Planning Committee

PLANNING COMMITTEE – 26 May 2021

Supplementary Agenda Advice

**Page 18 MC/21/0440 Medway Bridge Marina, Manor Lane,
Rochester, Borstal**

Original elevation (248 and 246) New passed
 (and built) elevation (248 and 246) Original Birdseye
 246 New passed Birdseye 246

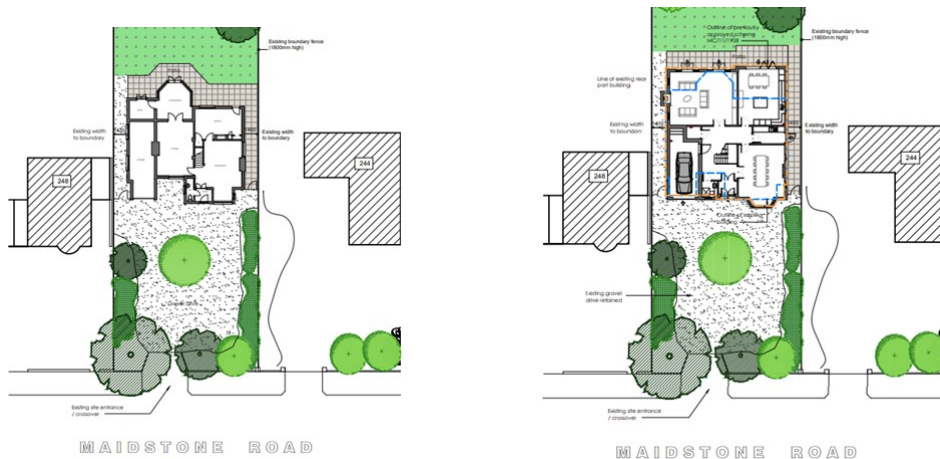
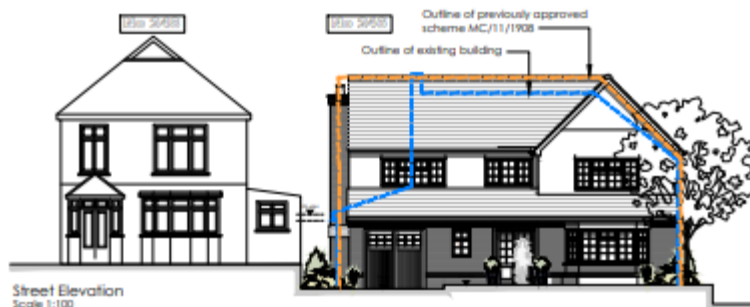
There has already been precedent set for this case with my neighbour back in 2014. An application was passed MC/13/1953 | Demolition of existing dwelling and construction of a 5-bedroomed detached dwelling with associated parking. | 246 Maidstone Road Chatham ME4 6JN and MC/14/3444 | Details pursuant to condition 03 on planning permission MC/13/1953 for demolition of existing dwelling and construction of a 5-bedroomed detached dwelling with associated parking | 246 Maidstone Road Chatham ME4 6JN where they had a single story garage built on the boundary, just the same as me, and demolished this and build a new house with a two story extension, including large gable

wall, with the side wall of their house extending 2 meter beyond the original length of the house. they also had to under pin the side of my house in order to achieve this, which i obviously wont have to do. The distance between my house and No250 is less than 3.2meter detailed above. i am obviously seeking a much smaller development than this, with two small pitched roofs (in order to let additional light in) with no Gabel end. elevations of this are provided in this email show my house and No 246.
